ADDENDUM NUMBER 02

Name: FELIX FRAGA ACADEMIC CAMPUS VIEW CORRIDOR
Located at: 3700 Navigation
Houston, TX, 77003
HCC Project Number: IFB 21-02
PDG Job Number: 19298
Dated: October 21, 2020

1.01 **A2.04 – FENCE DETAILS**

FENCE DETAILS

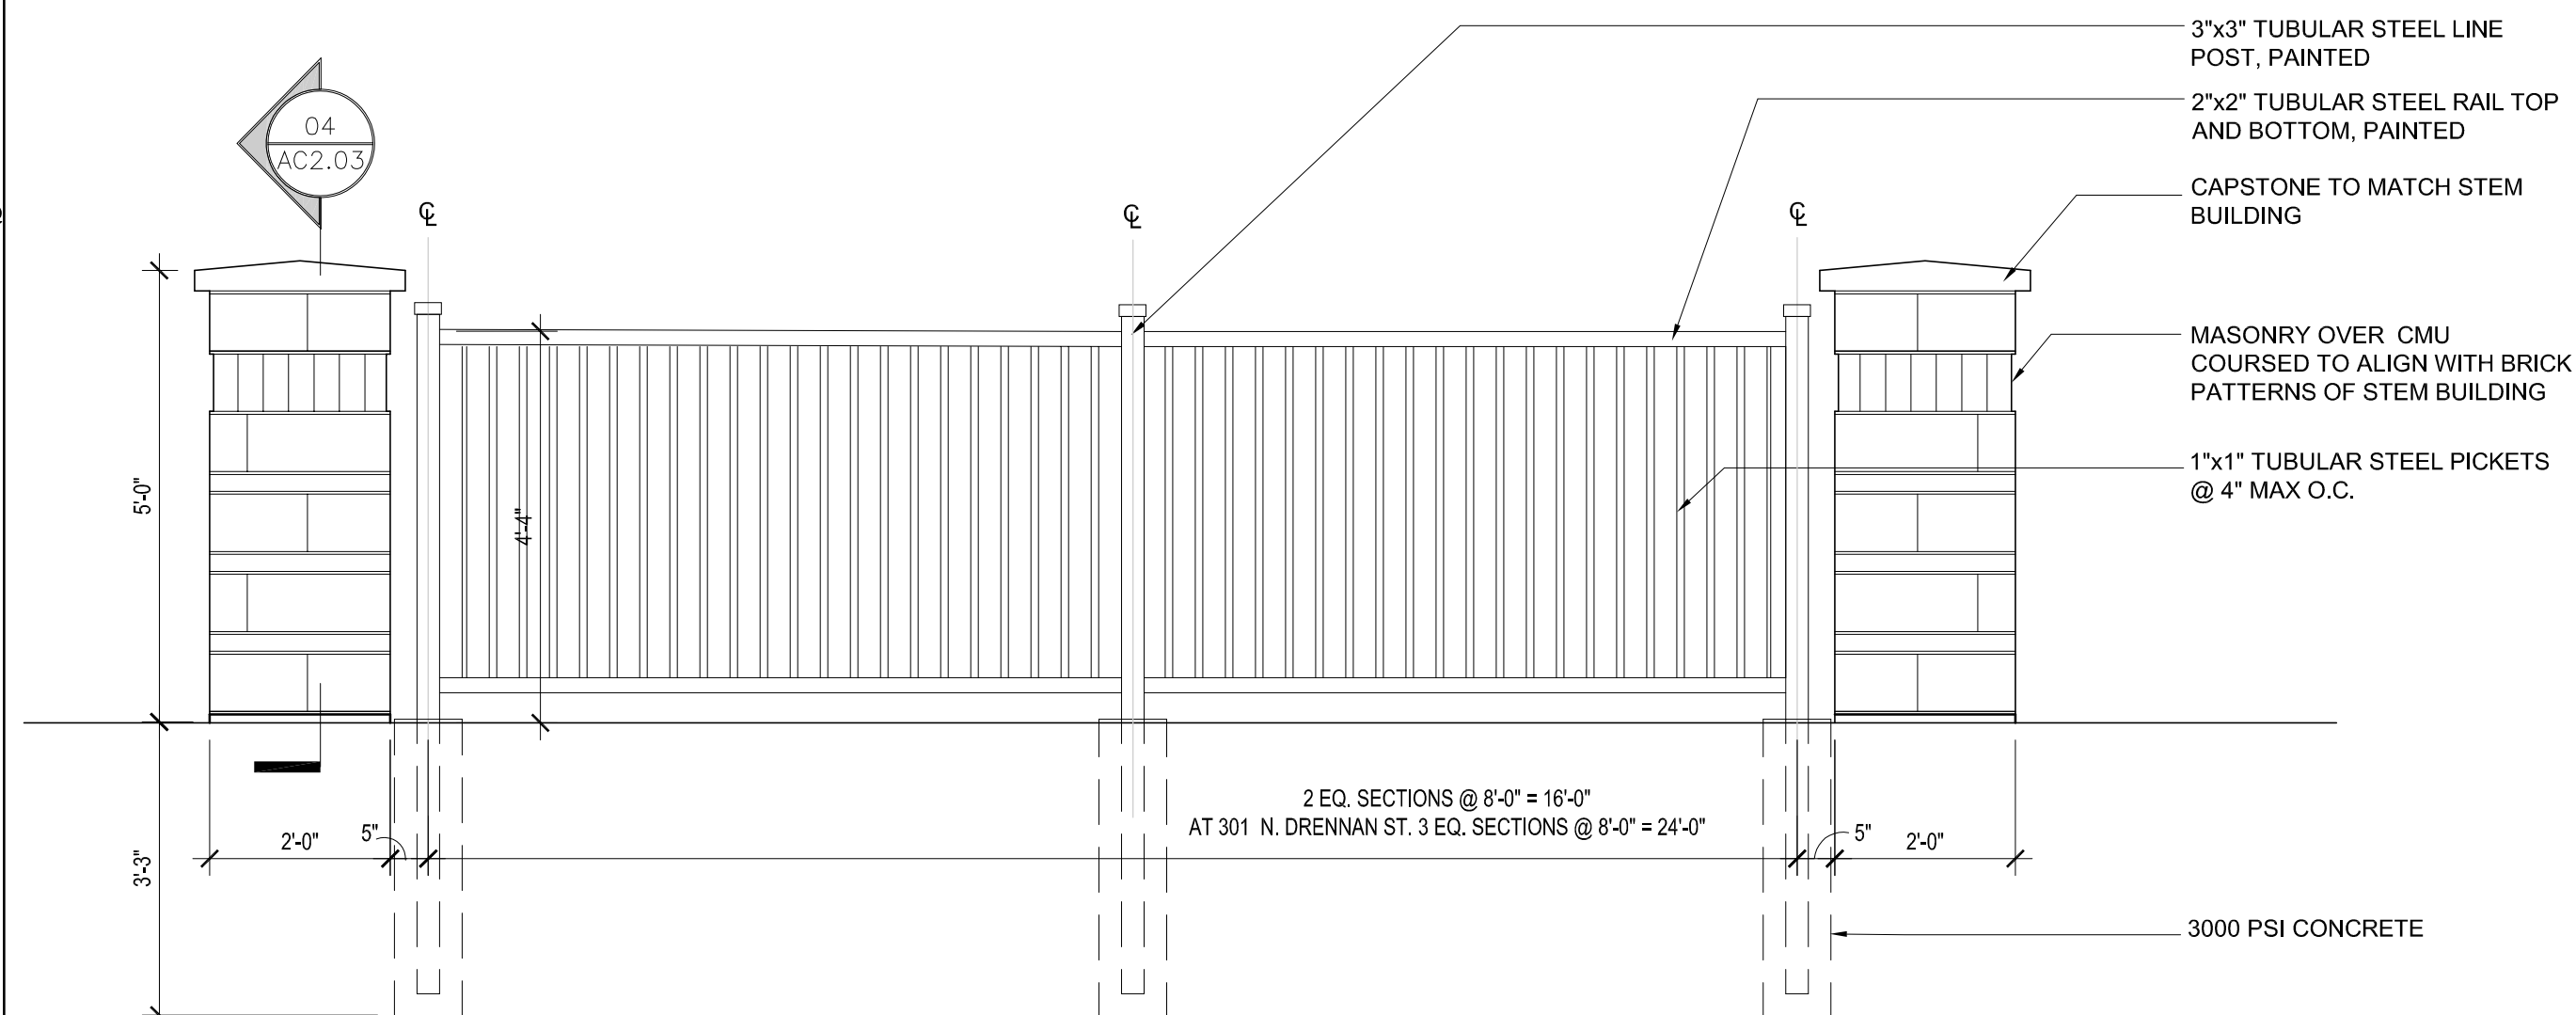
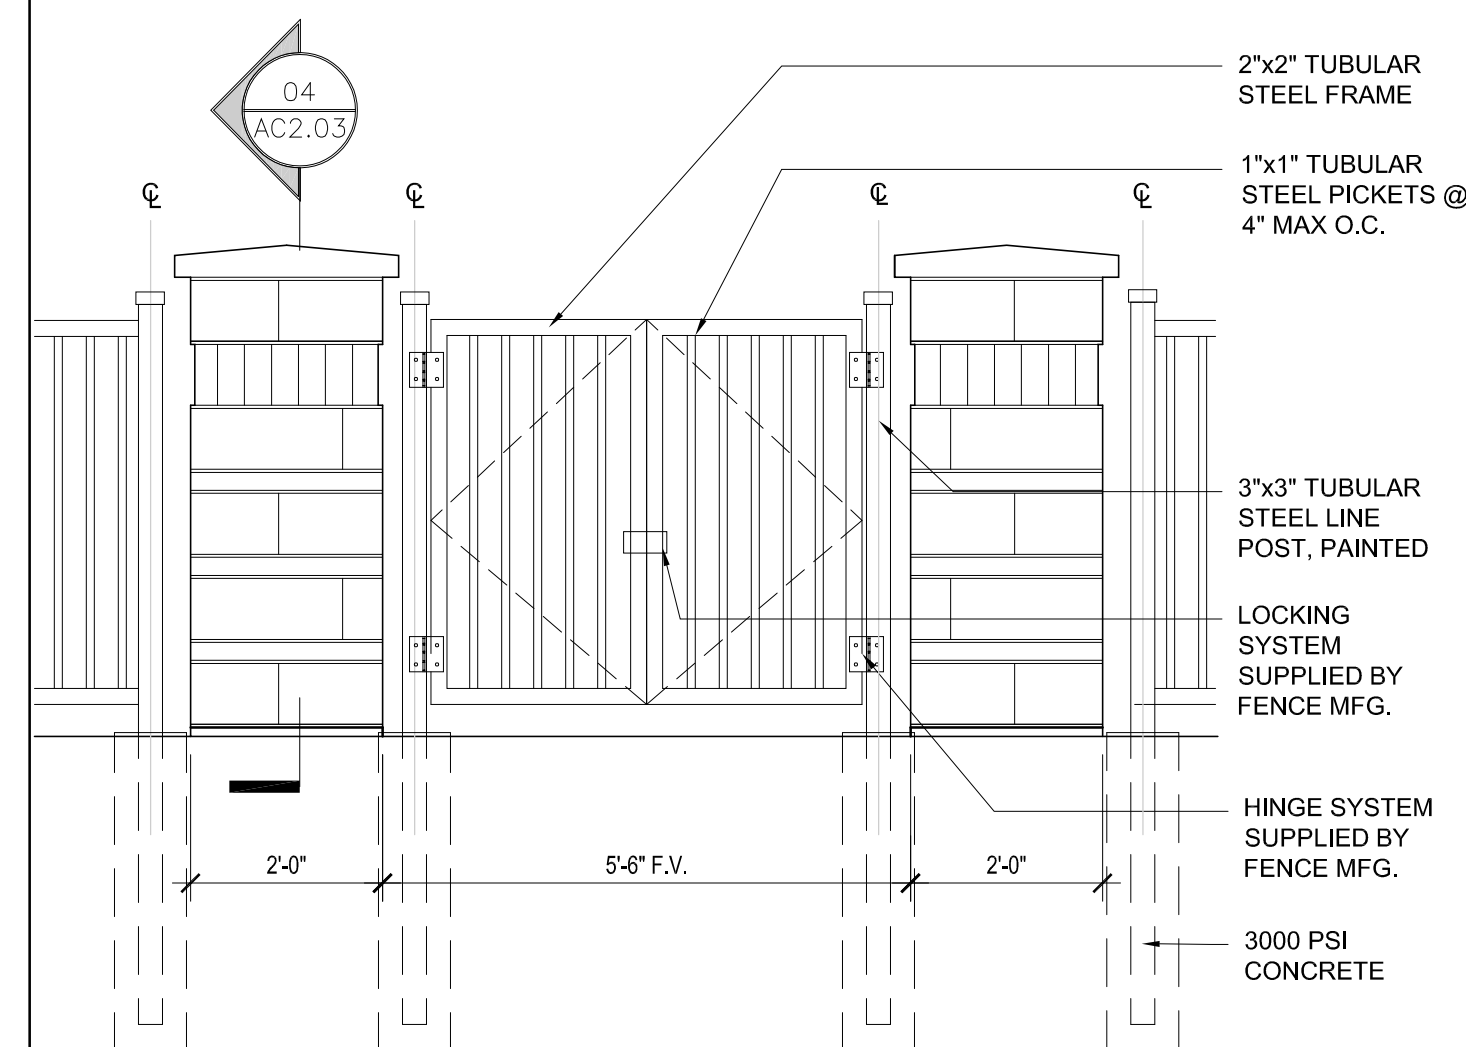
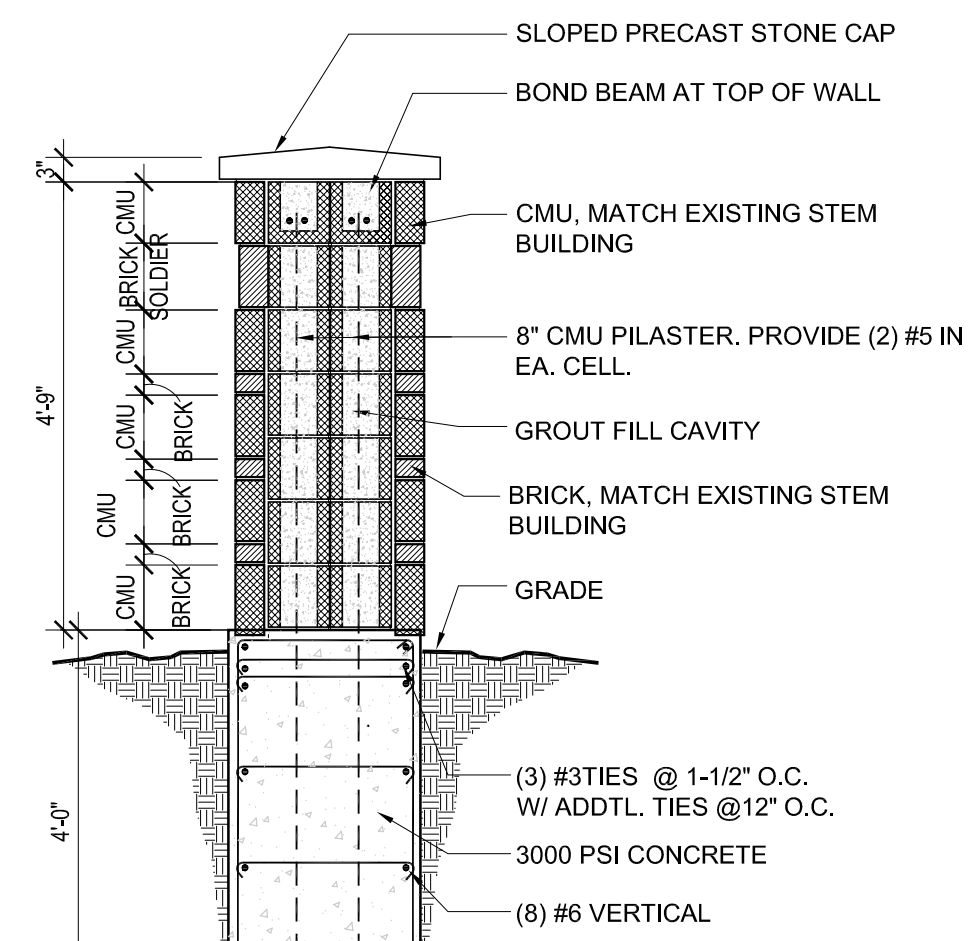
- Q1. Is there a form for the bid alternates?
Response: Bid List of Add-On Alternates has been provided as Exhibit 1 to the Solicitation.
- Q2. The plans have two A2.02 sheets and no sheet A2.04 which should be the alternate # 6 fence details according the drawings index, But on the alternate # 6 it states fence as per sheet A1.04 which is the fence at the basketball court. Also the specifications appear to indicate a typical picket fence. Please clarify.

Response: Please find enclosed sheet A2.04. Scope of Bid Alternate #6 is to replace sections of the fence along Bering Street. Extent of demolition of existing fence is shown on sheet A1.01, and typical elevations of replacement fence are shown on sheet A2.04.
